UNITED STATES PATENT AND TRADEMARK OFFICE

APPLICATION NO.	FILING DATE	FIRST NAMED INVENTOR	ATTORNEY DOCKET NO.	CONFIRMATION NO.
10/617,598	07/11/2003	Dean L. Kamen	1062/D77	2911
2101	7590	10/07/2004	EXAMINER	
BROMBERG & SUNSTEIN LLP 125 SUMMER STREET BOSTON, MA 02110-1618			ROYAL, PAUL	
			ART UNIT	PAPER NUMBER

Office Action Summary	Application No. 10/617,598	Applicant(s) KAMEN ET AL.	
	Examiner Paul Royal	Art Unit 3611

DETAILED ACTION

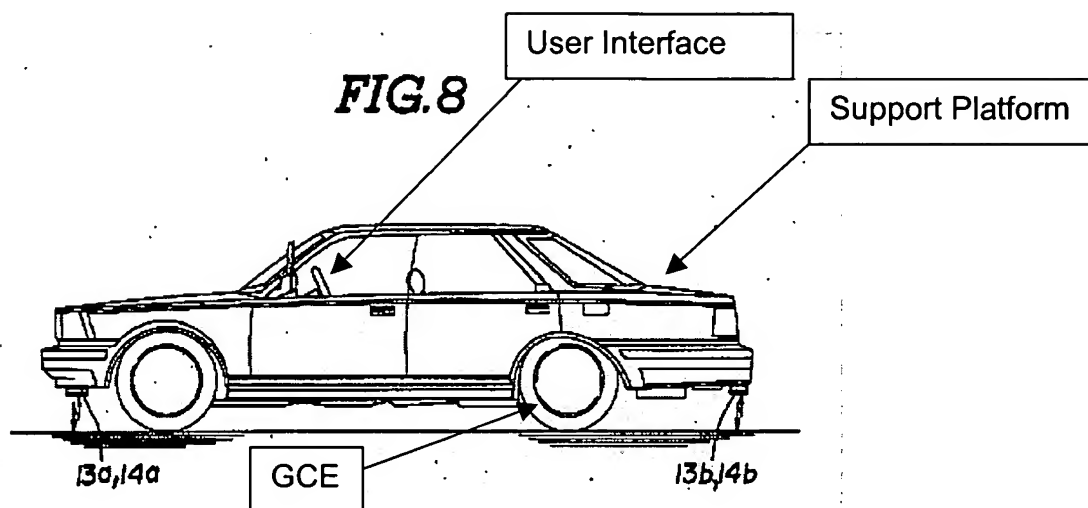
Kishi et al. teaches a vehicle including a pitch/roll sensor system comprising:
a support platform (Support Platform, see Examiner's annotated Figure 8) for supporting the load, the support platform characterized by a fore-aft axis, a lateral axis, and an orientation with respect to the surface, the orientation referred to as an attitude;
at least one ground-contacting element (GCE, see Examiner's annotated Figure 8) coupled to the support platform in such a manner that the attitude of the support platform is capable of variation;
a sensor module (13a,13b,14a, 14b) for generating a signal characterizing the attitude of the support platform; and

a controller (20) for commanding the motorized drive arrangement based at least on the attitude of the support platform or based on a position of a center of mass of the load relative to the at least one ground-contacting element,

a user interface (User Interface, see Examiner's annotated Figure 8), wherein the attitude of the support platform is capable of variation based on a signal generated by the user interface, wherein the controller commands motion in the fore-aft and lateral planes, such as pitching and rolling generated by turning the vehicle via the user interface.

For claim 4, note the sensor module senses the distance between a point on the platform and a position on the surface disposed at a specified angle with respect to the support platform.

For claim 8, note Kishi et al. teaches the sensor can be an ultrasonic distance sensor.

Note where Kishi et al. teaches a system responsive to vehicle driving, it is inherently understood to include a motorized drive arrangement for driving the at least one ground-contacting elements.
